## Executive Director's Recommendation

Commission Meeting: October 6, 2022

<b>PROJECT</b> <b>11th Street Bridge Park</b> 11th Street Bridge Southeast, Washington, DC	<b>NCPC FILE NUMBER</b> 7755  <b>NCPC MAP FILE NUMBER</b> 8.10(70.00)45568
<b>SUBMITTED BY</b> District of Columbia Department of Transportation	<b>APPLICANT'S REQUEST</b> Approval of final site development plans
<b>REVIEW AUTHORITY</b> District Projects Outside the Central Area per 40 U.S.C. § 8722(b)(1)	<b>PROPOSED ACTION</b> Approve final site development plans with comments  <b>ACTION ITEM TYPE</b> Staff Presentation

Approval of Final Site Development Plans

# Proposed Lighting Plan

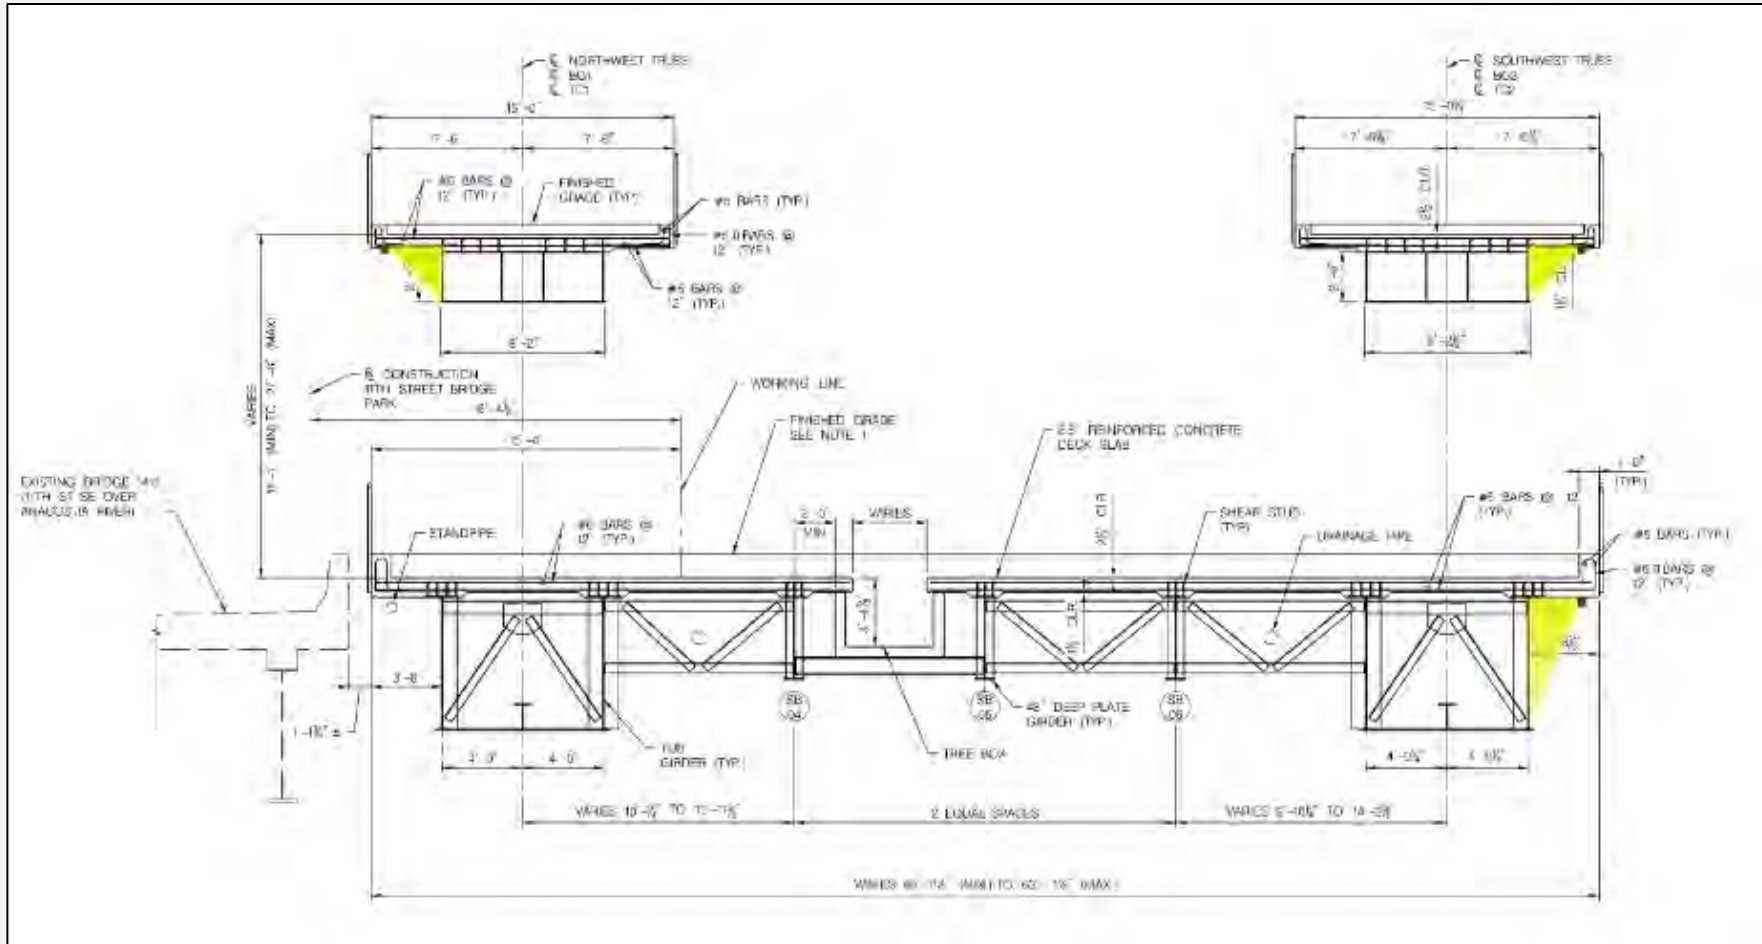
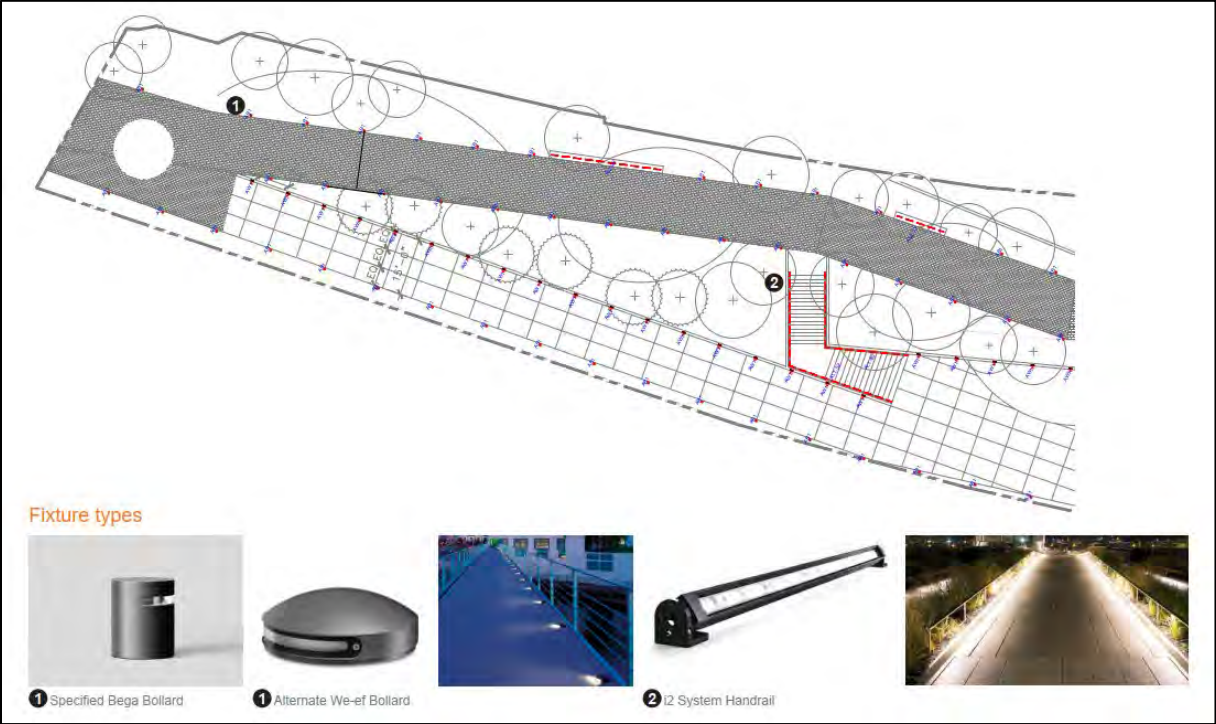
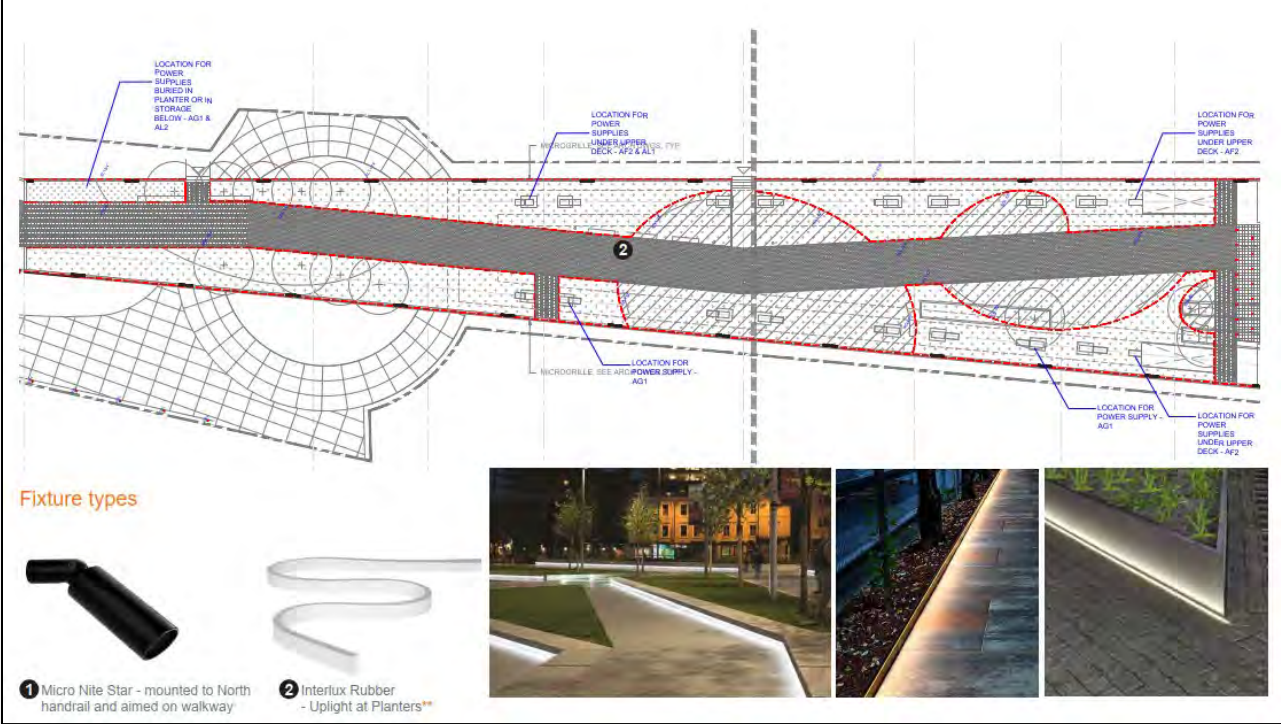
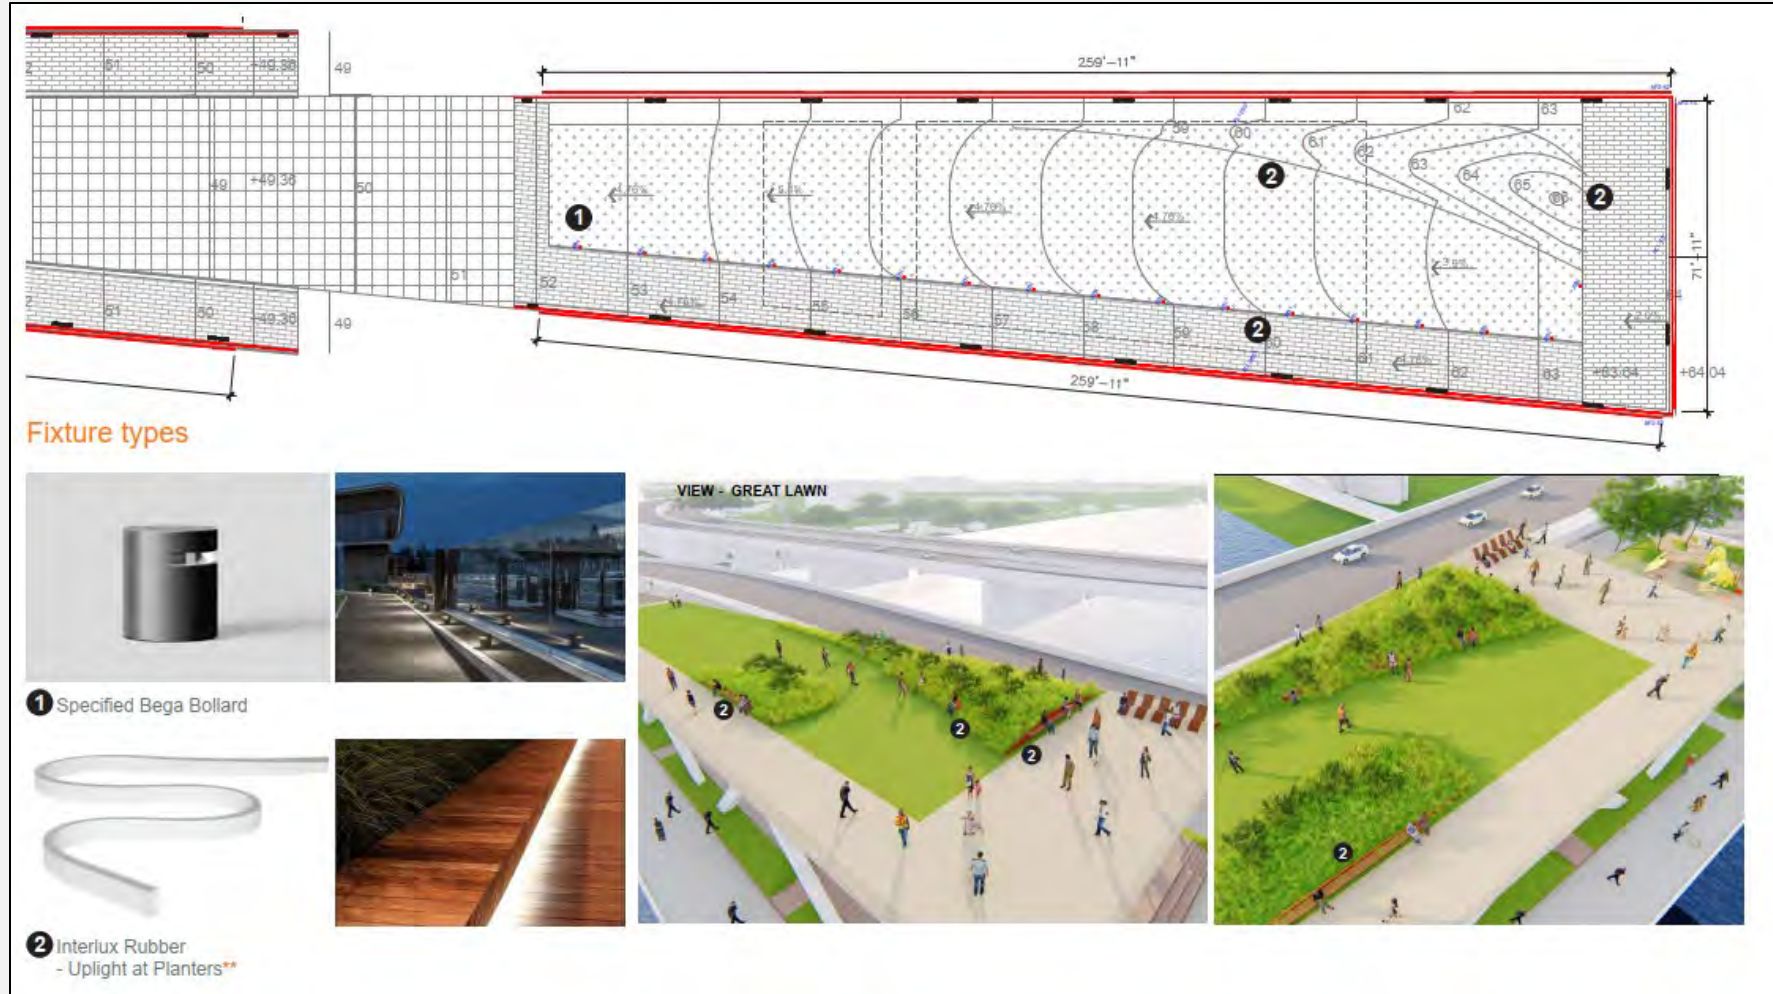
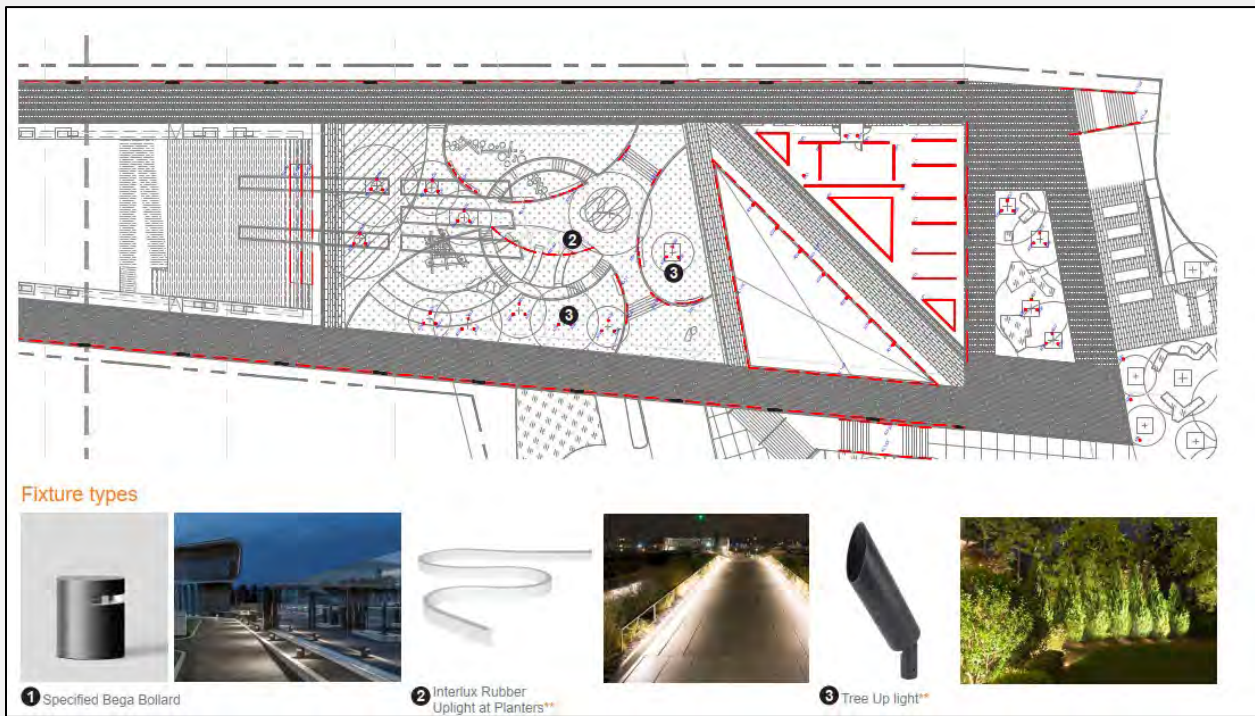
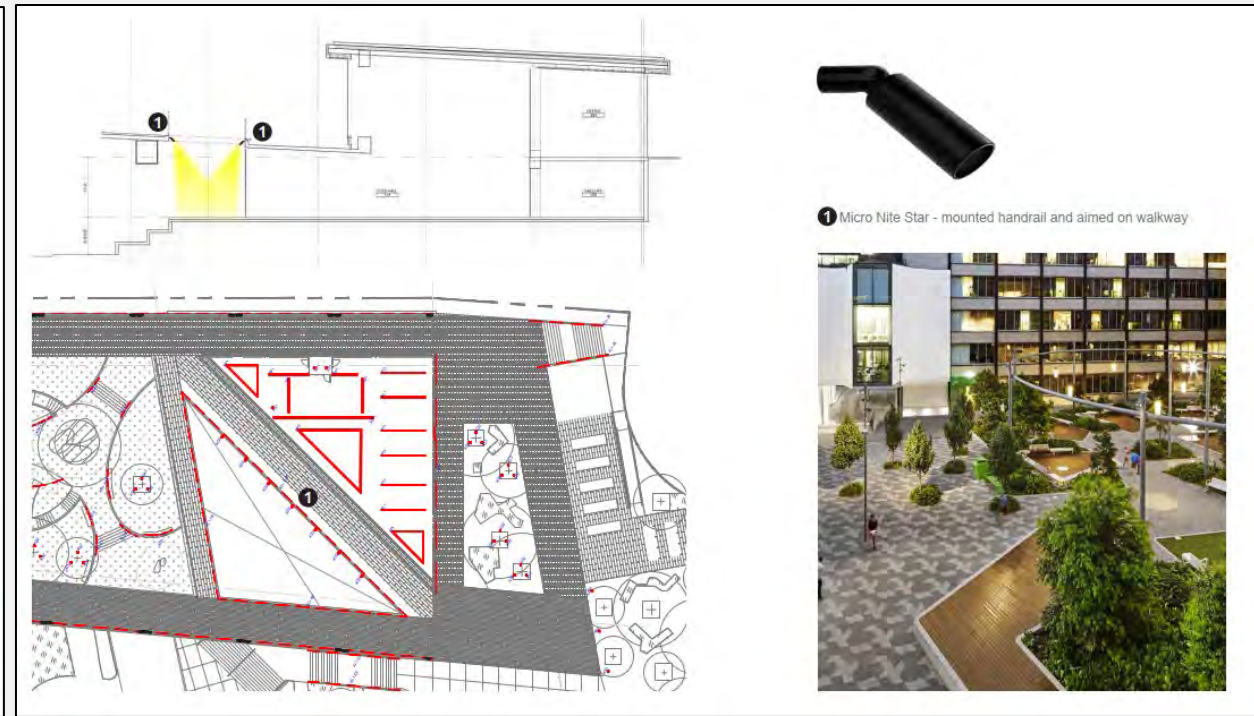
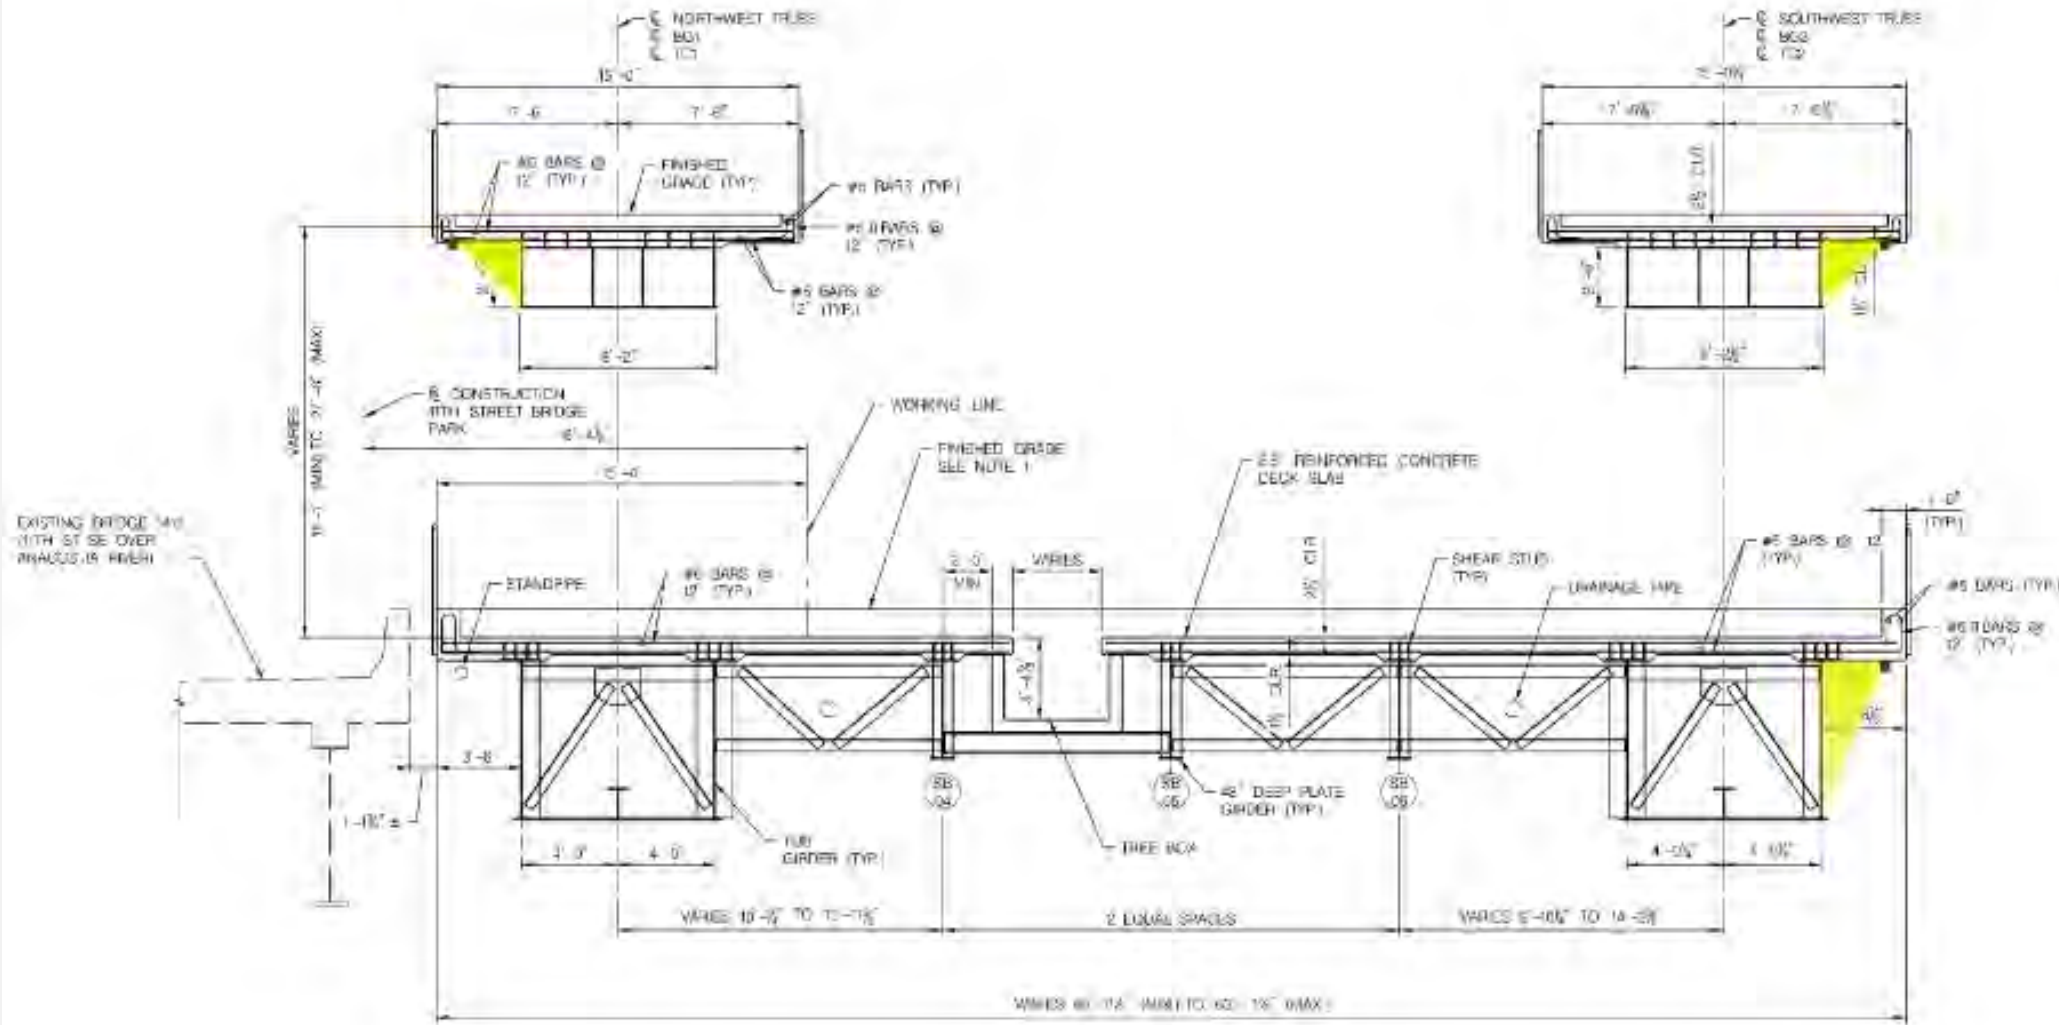
**Notes** the applicant provided additional information regarding the lighting plan, including illumination levels and renderings, to demonstrate the cumulative lighting impacts, per the Commission's previous request.

**Notes** the bridge structure is unique in that it also functions as a park, and therefore includes a combination of both bridge and park lighting. The bridge and park decking will be a new structure with a contemporary design that is not located within or visible from the Monumental Core.

**Finds** architectural lighting for the bridge and park are appropriate given its function, location and contemporary design.

setting and adjacent neighborhoods, per the Commission's request. As the bridge will be visible from areas near and along the river, which is also a natural riparian corridor, the lighting design is important. The applicant has indicated that the park will not be open at night, similar to other District parks and will only allow people to pass through the park at night. The proposed lighting achieves the Leadership in Energy and Environmental Design (LEED) Light Pollution Reduction credit using the Backlight, Up light, and Glare (BUG) method. As such, lighting levels will be appropriate to meet design needs and minimum safety standards, while minimizing excess light, as well as upward and horizontal spillage. Therefore, the applicant provided additional information regarding the lighting plan, including illumination levels and renderings, to demonstrate the cumulative lighting impacts, per the Commission's previous request. In addition, staff recommends the **Commission finds architectural lighting for the bridge and park are appropriate given its function, location and contemporary design.**
